CONTRACT CHANGE ORDER No. 170
SHEET ____ OF ____

## ROADWAY LEVEL WESTBOUND
### LIGHTING AND ELECTRICAL SYSTEMS
SCALE: 1:200

## ROADWAY LIGHTING POLE PLAN LOCATION-SHEET 27
### SKYWAY STRUCTURES
NO SCALE

**E-46**

**EE-36**

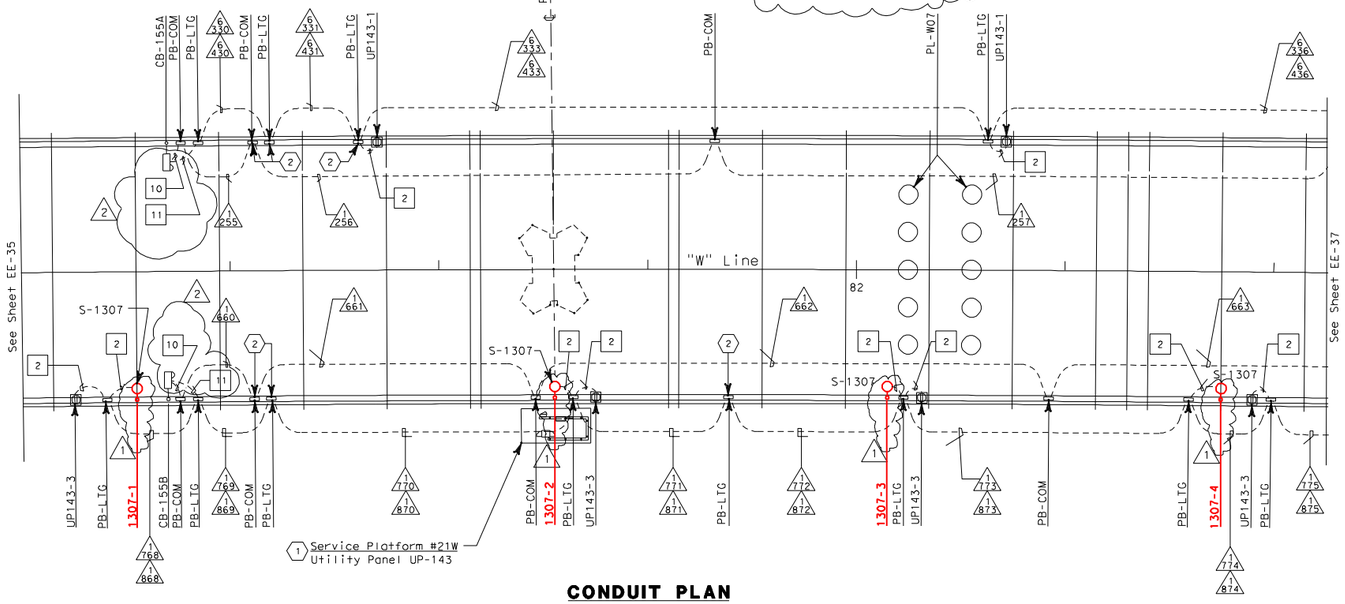
| MARK | DATE | DESCRIPTIONS | REV | CK | |
|---|---|---|---|---|---|
| 2 | 1/20/06 | Delete CB-155A & CB-155B. Coil 5 m of call box signal and power cable in adjacent PB-COM and PB-LTG pull boxes. | JE | EJL | CCO No. 170 |
| 1 | 3/2/05 | Delete Roadway light poles and fixtures. Coil 10m, 3#10 conductors in the pull box adjacent to light pole locations. | RS | PB | CCO No. 123 |
